CONTRACT CHANGE ORDER NO. \_\_\_\_\_  
SHEET \_\_\_\_ OF \_\_\_\_

ALTERNATE BARRIER DETAILS -  
CONNECTION BEFORE LOAD TRANSFER

SAN FRANCISCO OAKLAND BAY BRIDGE  
EAST SPAN SEISMIC SAFETY PROJECT  
SELF-ANCHORED SUSPENSION BRIDGE  
(SUPERSTRUCTURE & TOWER)  
BARRIER DETAILS NO. 2C

PLAN-STEEL BARRIER Type 732 Modified for W5 E2  
1:10 (See Note 13)

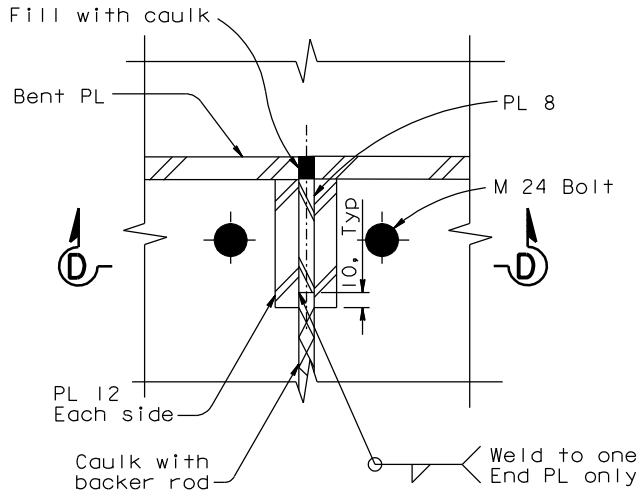
MARK	DATE	DESCRIPTIONS	BY	CH'D	CCO#
	04/05/10	BARRIER MODIFICATIONS	GB	MN	44
		REVISIONS

- Between PP 120+350 and PP 120+1250, the Contractor shall provide shim plates under the barrier base plates and under the barrier connections as required to fill the gap caused by the OBG kink. The 68 Dia drainage cut-out in the barrier diaphragm shall not be blocked, and the caulk shall be thickened under the barrier along the curb lines between these panel points.

- Bolt holes shall be standard size in the deck PL and oversize in the barrier.
  - All bolts between the barrier and the deck shall be tensioned prior to load transfer.

- For Section C-C and Details not shown for Lines W5/E2, see "Barrier Details No. 1".
  - Following installation of all HS bolts all anchor rods for barrier segment shall be installed snug tight. They shall then be tightened by an additional one-half turn of the nut.
